Access Compliance Report Public Rights-of-Way (Curb Ramps)

Main Street: GRASSY_KNOLL_LN Cross Street: MEANDERING_TRAIL Location: NW

ADA ID: RPRK211019131615 Ramp Type: Type 4 - Parallel Initial Pass/Fail: Fail Overall Compliance: No Severity Score: 15

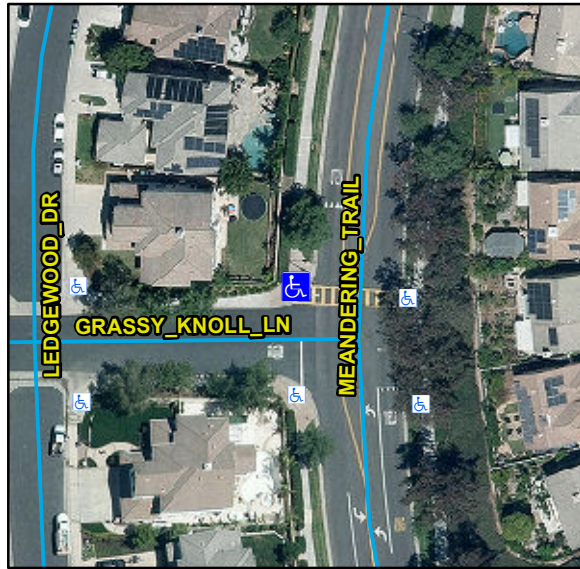
N/A

Compliance	Description	Data	Compliance	Description	Data
N/A	Ramp Length LT (in)	90	N/A	Ramp Length RT (in)	88
Yes	Ramp Width LT (in)	86	Yes	Ramp Width RT (in)	90
Yes	Ramp Run Slope LT (%)	1.6	Yes	Ramp Run Slope RT (%)	7.2
No	Ramp Cross Slope LT (%)	5.4	No	Ramp Cross Slope RT (%)	4.5
N/A	Landing Present	N/A	N/A	DWS Provided	N/A
N/A	Landing Length (in)	N/A	N/A	DWS Contrast	N/A
N/A	Landing Width (in)	N/A	N/A	DWS Length (in)	N/A
N/A	Landing Run Slope (%)	N/A	N/A	DWS Full Width	N/A
N/A	Landing Cross Slope (%)	N/A		DWS Offset Type	N/A
N/A	Landing Movement Obstructed?	N/A	N/A	DWS Offset Left (in)	N/A
	Landing Movement Type	N/A	N/A	DWS Offset Right (in)	N/A
N/A	Landing Shared	N/A			
N/A	Clear Space	Yes			
N/A	Clear Space To Crosswalk (in)	N/A			
N/A	Marked Crosswalk 1	No	N/A	Marked Crosswalk 2	Yes
	Crossing 1 Direction	S		Crossing 2 Direction	E
	Marked Crosswalk 1 Width (in)	N/A		Marked Crosswalk 2 Width (in)	144

Remove & Replace Curb Ramp With Two New Directional Ramps or Equivalent.

R204.3, R304.5.3, STD 1115
